July 7, 2008  
2004.33.8000 / 08P-244

Mr. Henry Eng, Director  
Department of Planning and Permitting  
City and County of Honolulu  
650 South King Street, 7th Floor  
Honolulu, HI 96813

**Application to Amend Special Use Permit File No. 72/SUP-1  
Makakilo Quarry – Response to Comments**

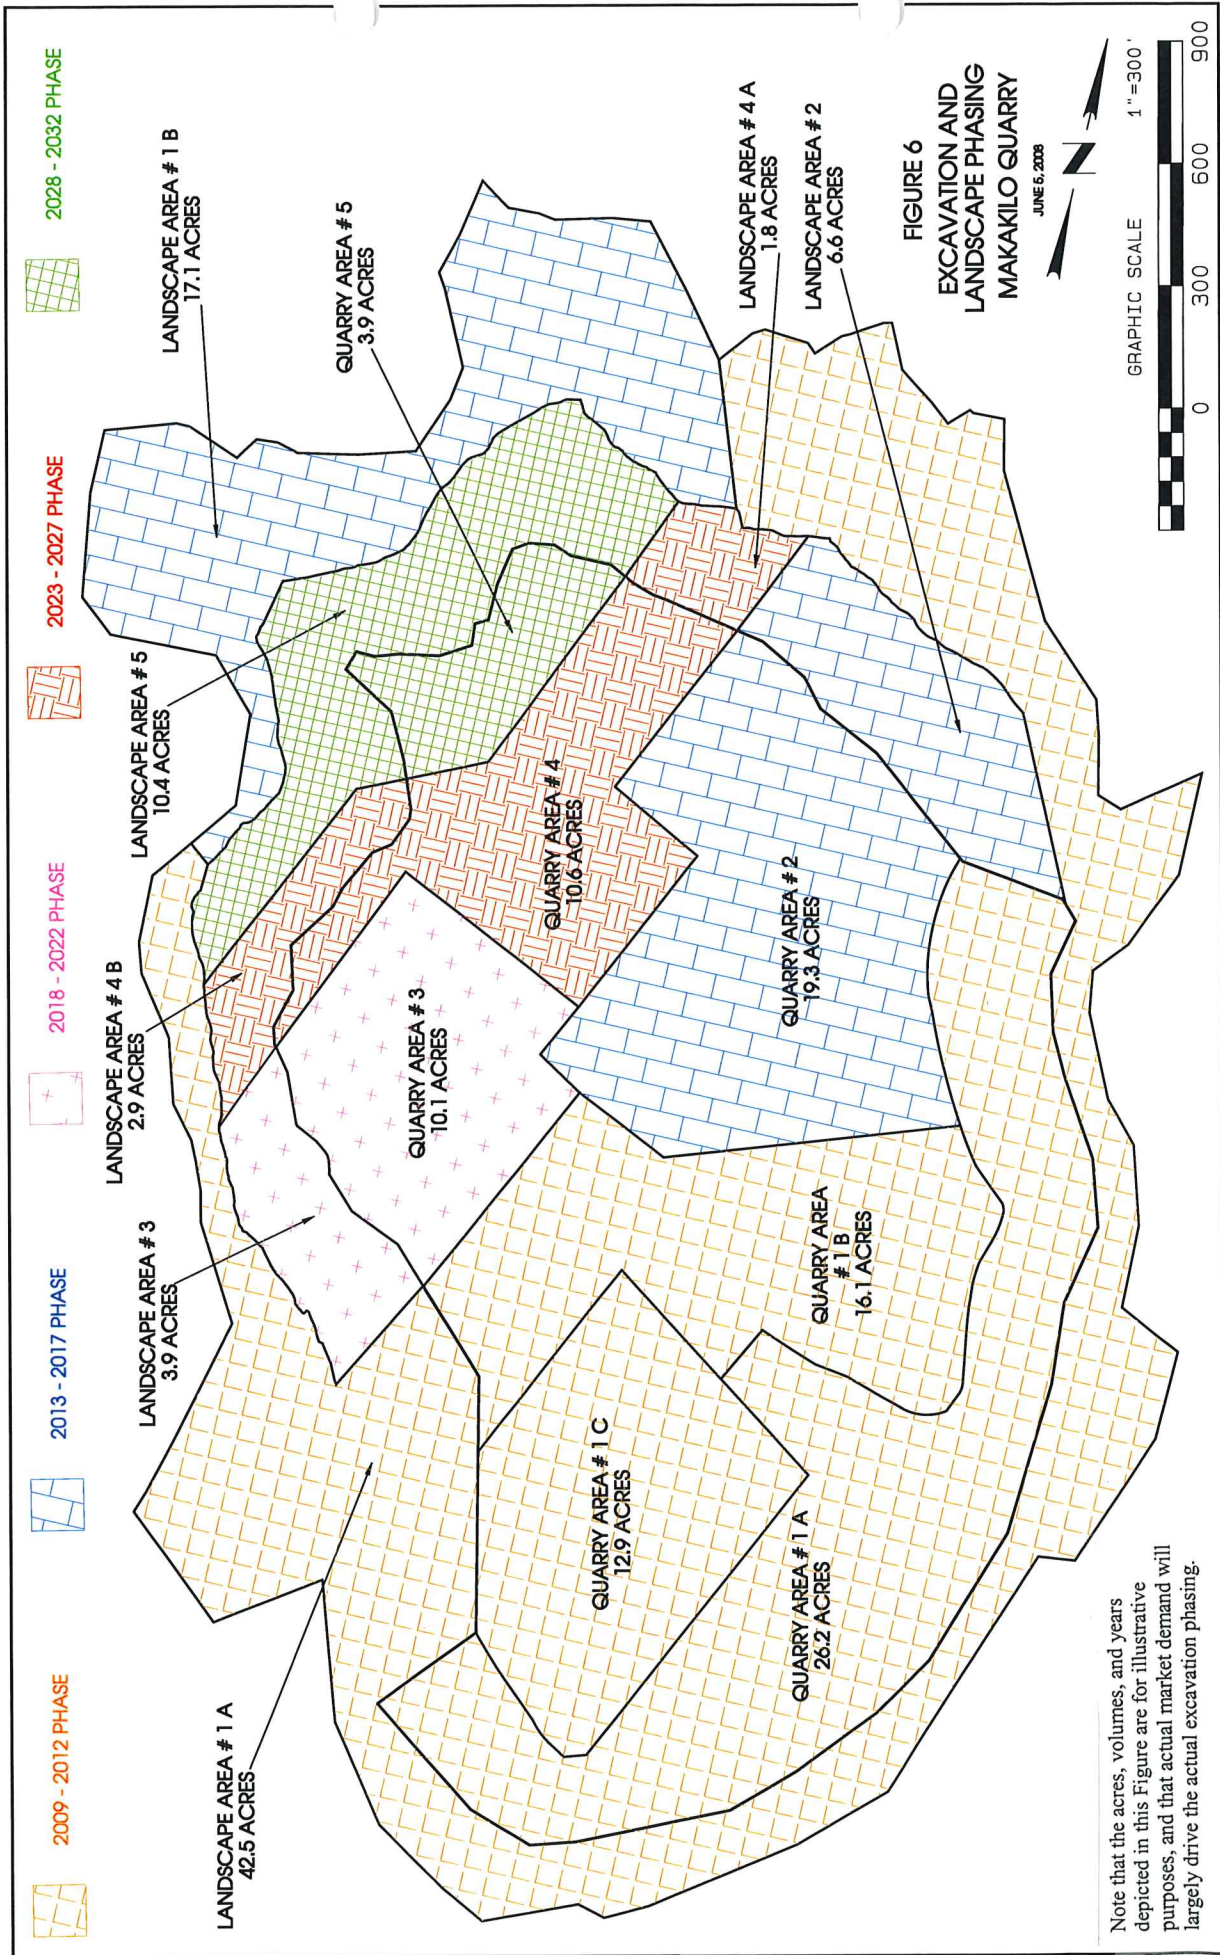
- 5) Revised Figures, Exhibits. A "Revised Excavation Phasing" plan, Figure 6 in Appendix B of the Engineering Report, a "Revised Renaturalization Matrix," Exhibit 4 in Appendix E, and a "Revised Renaturalization Phasing" Exhibit 5 in Appendix E of the Engineering Report, are attached, each reflecting changes arising from the Revised Grading Plan of June 5, 2008.

**FIGURE 7**  
**DESIGNATION OF**  
**AREAS AND ACRES**  
**MAKAKILO QUARRY**

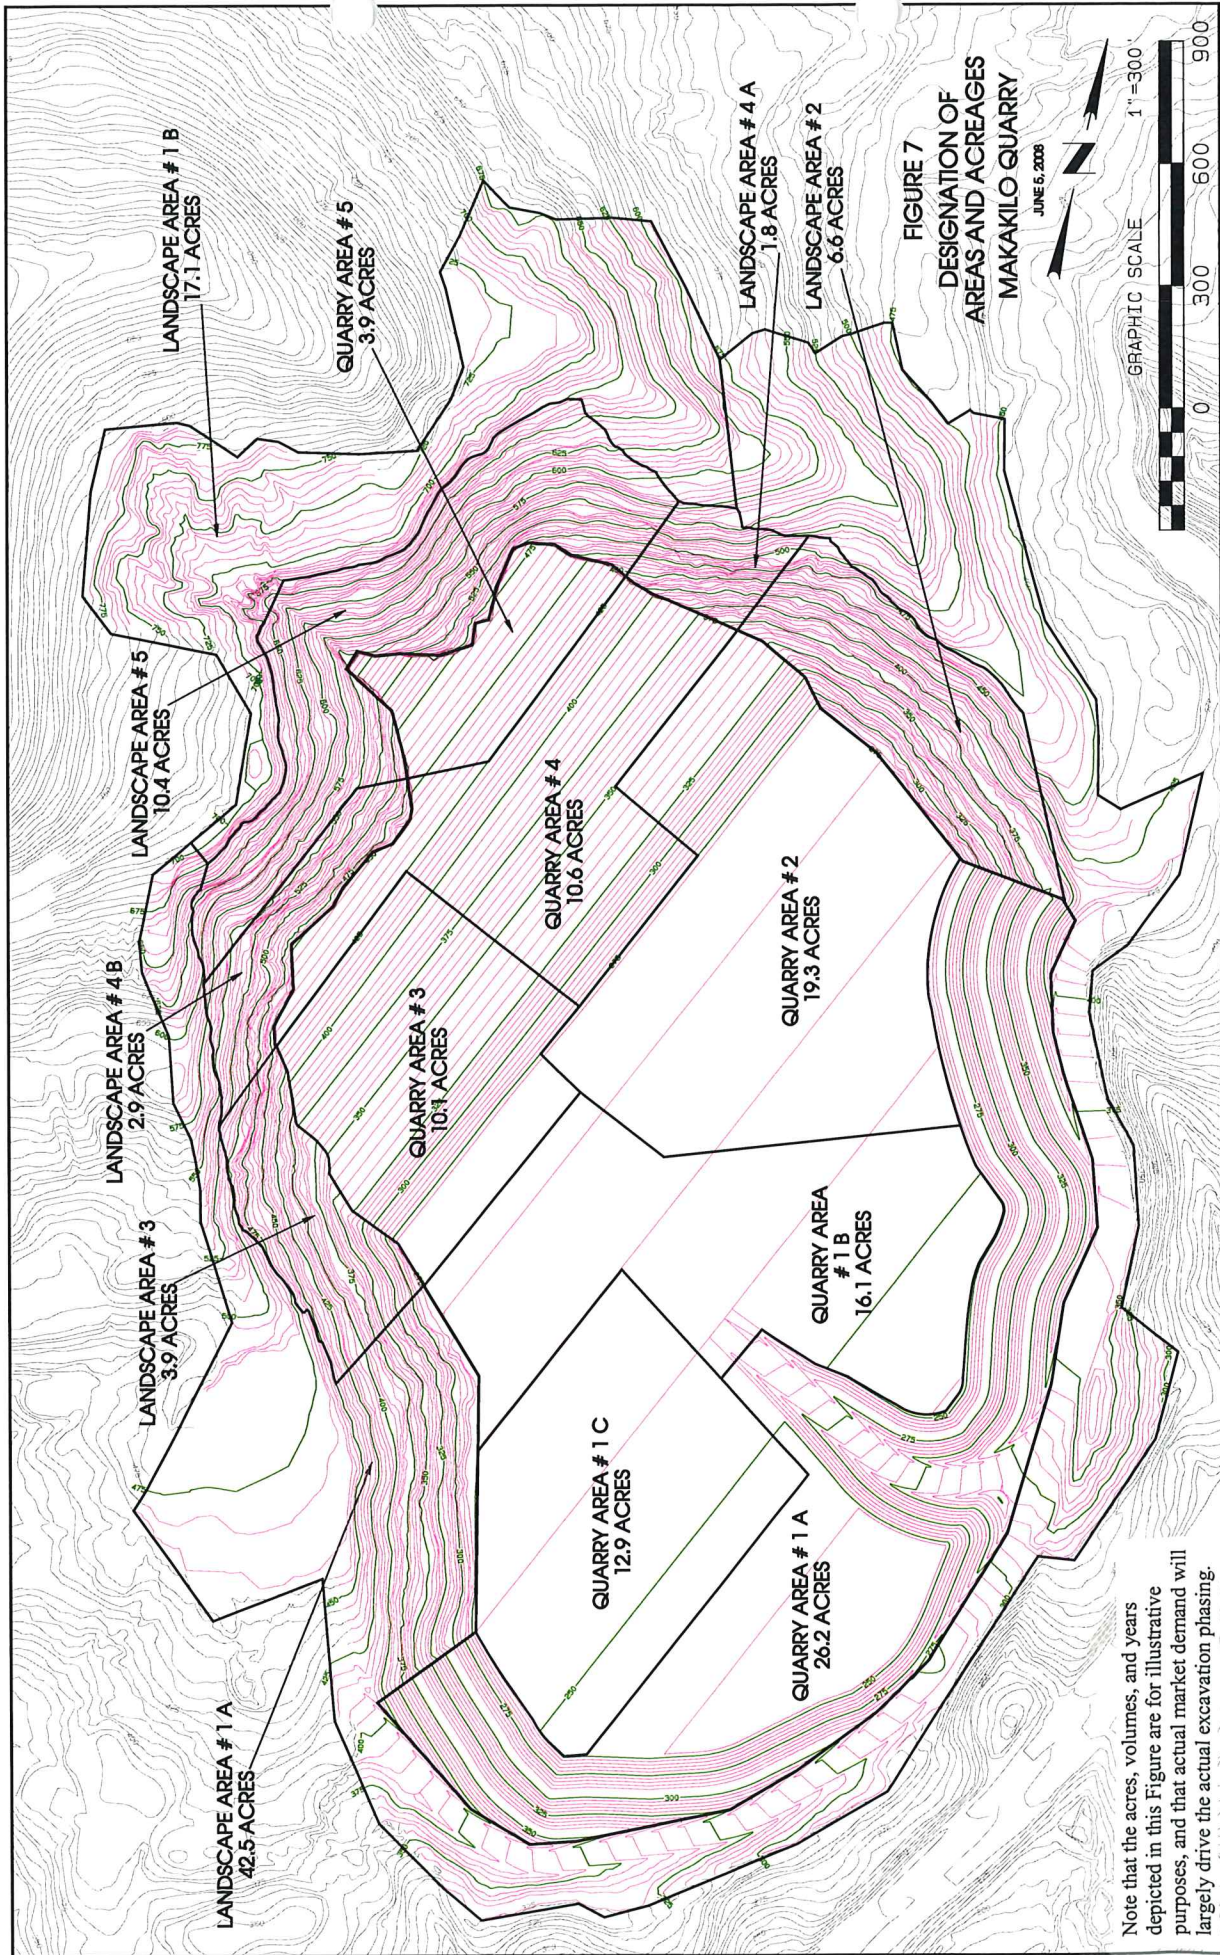
- 6) New Figure of Areas and Acreages. A new "Designation of Areas and Acreages" as Figure 7 for Appendix B of the Engineering Report is included to assist in reviewing this submittal. It is important to emphasize at this point that the acres, volumes and years depicted in the "Excavation and Landscaping Phasing" (Figure 6), the Renaturalization Matrix (Exhibit 4) and Renaturalization Phasing (Exhibit 5) are for illustrative purposes, and that actual market demand will largely drive the actual excavation phasing. While the initial landscape grading described by Areas 1A and 1B will be take place in the 2009-2012 and 2013-2017 periods due to the availability of irrigation water, thereafter the landscape grading will follow actual quarry excavation.
